Item Name: Quick Release Heli-Utility-Basket™ Long, HD Lid, Spacepod™/Squirrel Check Comp.

DART SERVICE INSTRUCTION

TO AMEND INSTALLATION INSTRUCTIONS D350-607-3 Rev.D,
INSTALLATION INSTRUCTIONS D350-607-4 Rev. C AND
INSTRUCTIONS FOR CONTINUED AIRWORTHINESS ICA-D350-607 REV. 6
REF TCCA STC: SH94-14
REF FAA STC: SR00213NY
REF EASA STC: EASA.10016996
REF BRAZILIAN STC: 2007S03-03/-04/-05/-06

FIGURE 1: INSTALLATION OF D4775-041 FWD STRUT

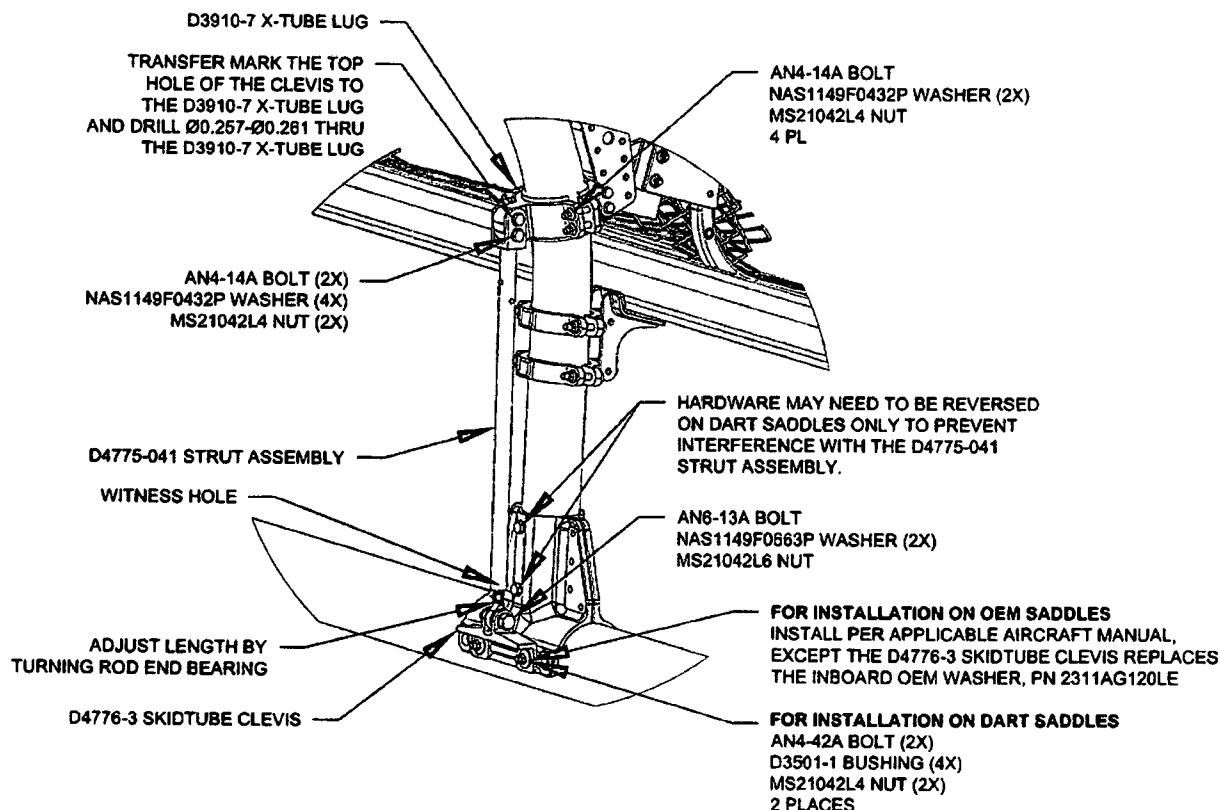
- 3.1 Substitute the Forward Lower D3910-5 X-Tube Lug with the D3910-7 X-Tube Lug as shown in Figure 1.
- 3.2 Install the forward D4775-041 Strut Assembly. Transfer mark from the upper hole on the clevis of the D4775-041 Strut Assembly to the D3910-7 X-tube Lug and drill thru the lug $\varnothing 0.257$ - $\varnothing 0.261$ as shown in Figure 1. Touch up chemical conversion coating per MIL-DTL-5541. Check the witness holes located at the bottom end of the D4775-041 Strut Assemblies to ensure that the thread from the rod end extends past the witness hole.
Torque MS21042L4/-4 nuts to 50-70 in-lbs (5.7-7.9 N-m). Torque MS21042L6/-6 nuts to 160-190 in-lbs (18.1-21.5 N-m).
- 3.3 Complete the installation in accordance with Installation Instructions D350-607-3 Rev. D or D350-607-4 Rev. C.
